TOWN OF CAPE ELIZABETH PUBLIC WORKS DEPARTMENT

Date: May 12, 2021
To: Maureen O'Meara, Town Planner
From: Jay Reynolds, Public Works Director 
Re: Review of Carr Woods Development: Deep Brook Road

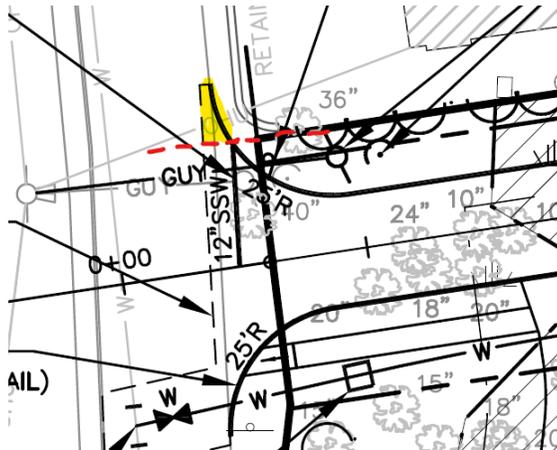
- In my initial pre-application conversation with the design engineer, it was noted that the proposed access/radius of Deep Brook Drive goes beyond the side property line and along the frontage of the neighboring property. The applicant should revise the entrance so that the radius does not encroach past the side property line of the development's lot. See sketch:
